SUNDRY NOTICE

1. OGCC Operator Number: 10079 API Number: 05-045-19098-00
2. Name of Operator: Antero Resources Piceance Corp OGCC Facility ID #
3. Well/Facility Name: BAT Well/Facility Number: 13D-17-07-95
4. Location (QtrQtr, Sec, Twp, Rng, Meridian): SESW, Sec 17, T7S, R95W, 6th P.M.

Upon pressure testing the BAT 13D-17-07-95 wellbore, Antero discovered multiple casing collars with marginal leaks. Injection was not possible into these collars. As such, in preparation for a completion attempt on this well, Antero recommended the following procedure to Kevin King, COGCC Engineer, and received verbal approval on 8/13/2010 to proceed.

Wellbore Diagram
(Current 8/13/10)

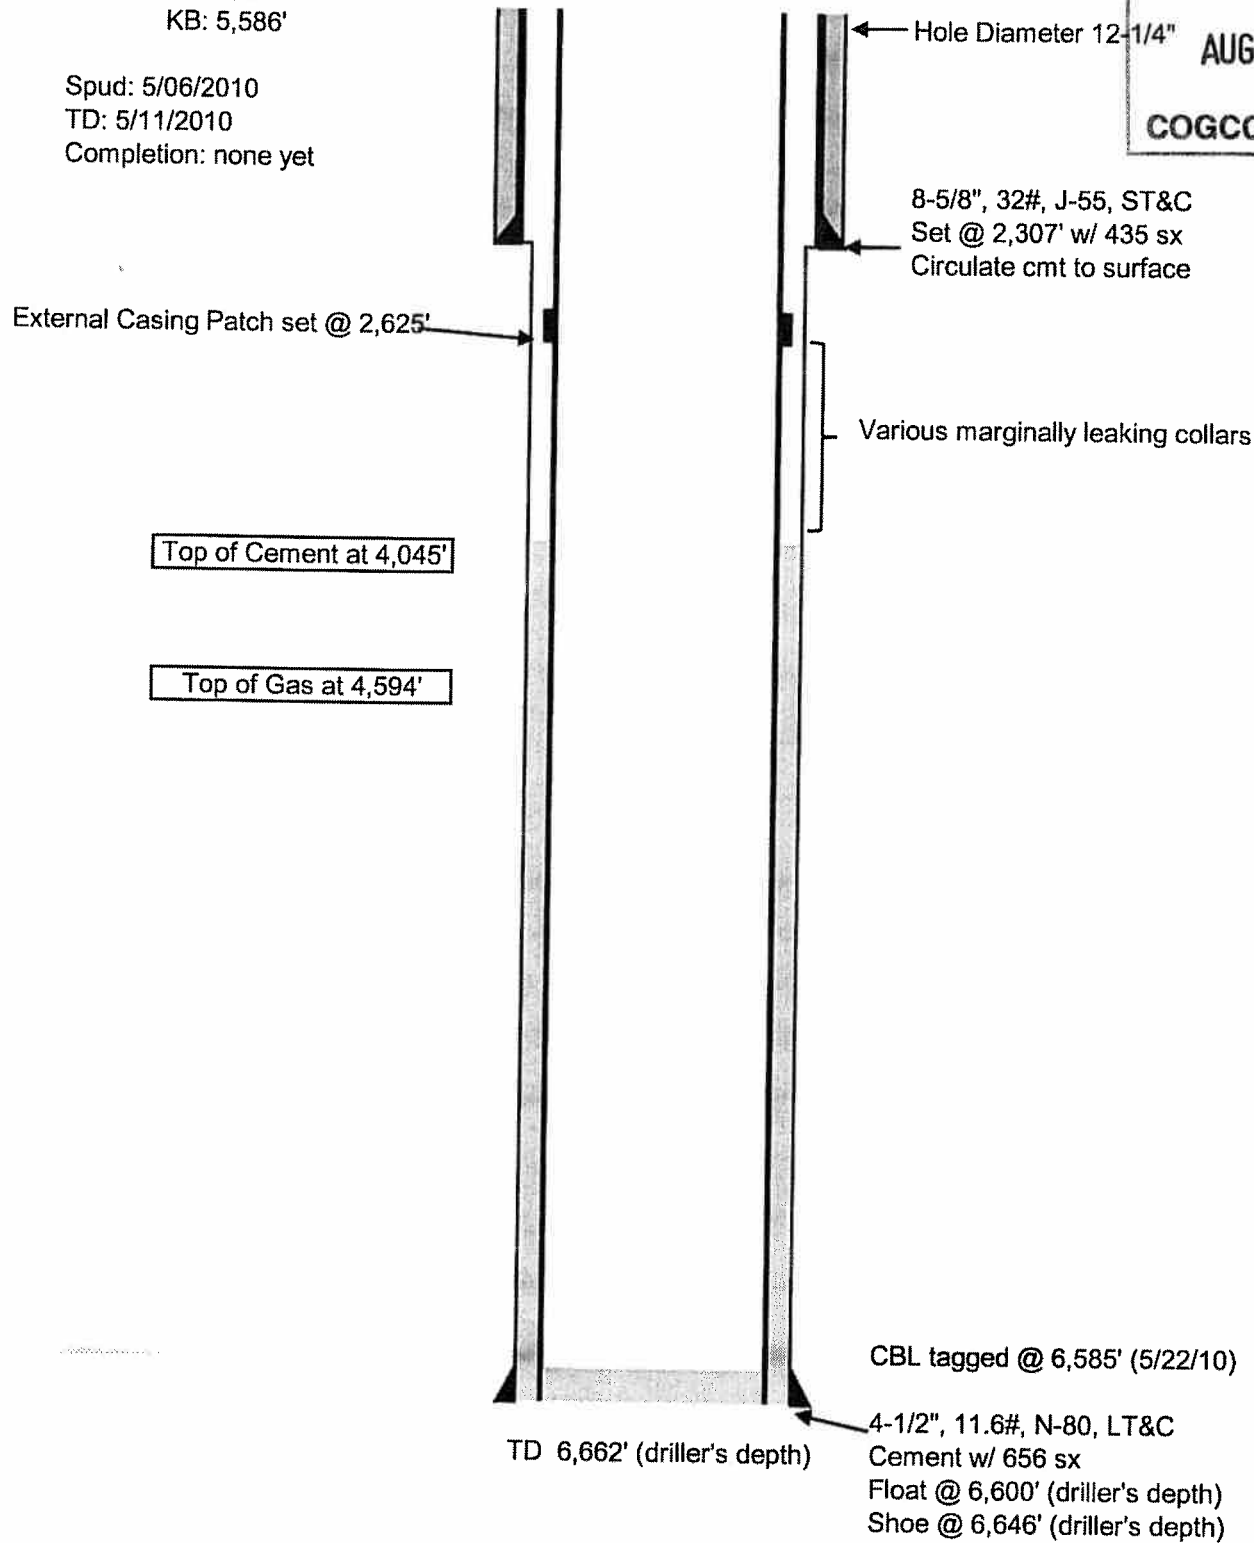
1. Perforate squeeze holes @ 4,025' (above current top of cement)
2. RU pump and establish circulation to surface via 4-1/2" x 8-5/8" annulus.
3. RIH w/ cement retainer and set @ ~3,975'.
4. Pump adequate cement volume to bring top of cement to ~2,500' (200' below surface casing shoe).
5. Run CBL from top of retainer (3,975') into surface pipe (2,307').
6. Drill out cement retainer and cement from wellbore.
7. Pressure test casing to 5,000 psi for upcoming stimulation work.
